# **ADDENDUM NO. 2**

**SPIETH HALL ROOF REPLACEMENT AND  
MECHANICAL UPGRADE**

**PROJECT NO. 950599**

### Addendum #1 Work Sequence Narrative

Sheet No.  
**E6.2**  
 OF

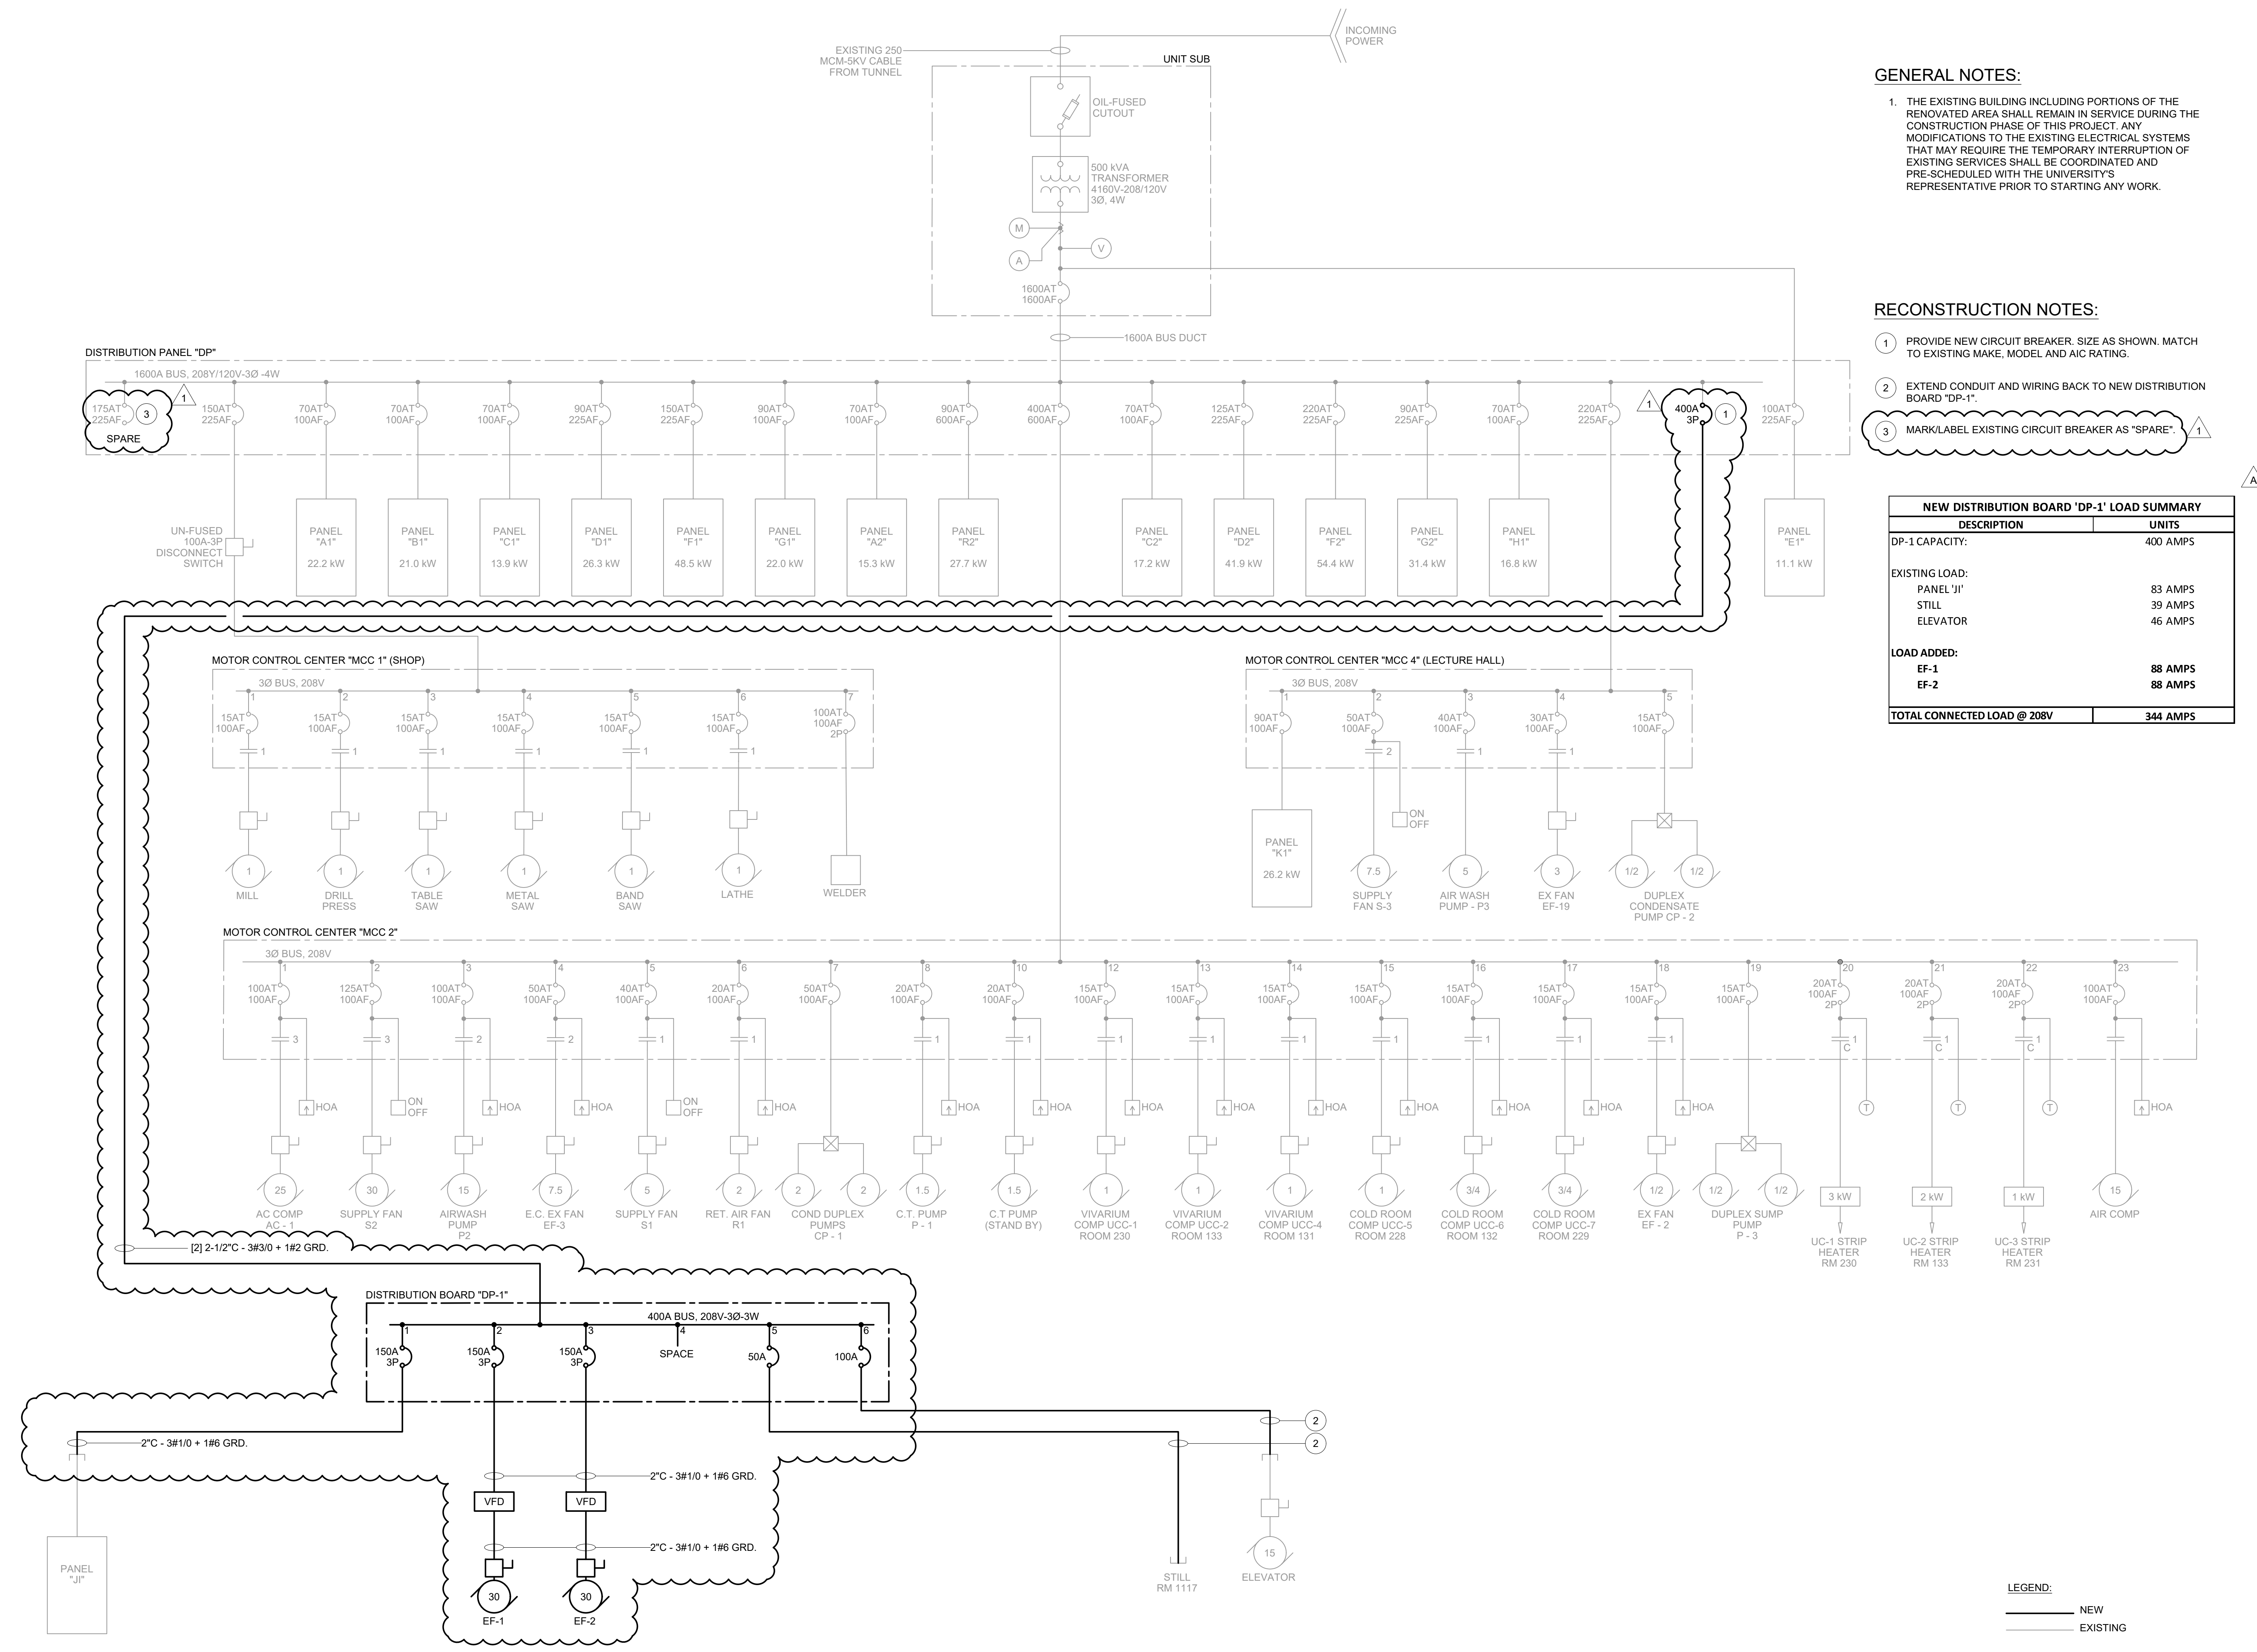
##### Sheet E6.2:

1. In existing Distribution Panel 'DP', the existing 175AT/225AF circuit shall be labelled as 'SPARE', as shown on reconstruction note 3.
2. Connection or routing to new Distribution Board 'DP-1' was revised to be served by a new 400A-3P circuit breaker from the existing 150A circuit breaker that was removed.

- 1 PROVIDE NEW CIRCUIT BREAKER. SIZE AS SHOWN. MATCH TO EXISTING MAKE, MODEL AND AIC RATING.
- 2 EXTEND CONDUIT AND WIRING BACK TO NEW DISTRIBUTION BOARD "DP-1".
- 3 MARK/LABEL EXISTING CIRCUIT BREAKER AS "SPARE".

NEW DISTRIBUTION BOARD "DP-1" LOAD SUMMARY	
DESCRIPTION	UNITS
DP-1 CAPACITY:	400 AMPS
<b>EXISTING LOAD:</b>	
PANEL "J1"	83 AMPS
STILL	39 AMPS
ELEVATOR	46 AMPS
<b>LOAD ADDED:</b>	
EF-1	88 AMPS
EF-2	88 AMPS
<b>TOTAL CONNECTED LOAD @ 208V</b>	<b>344 AMPS</b>
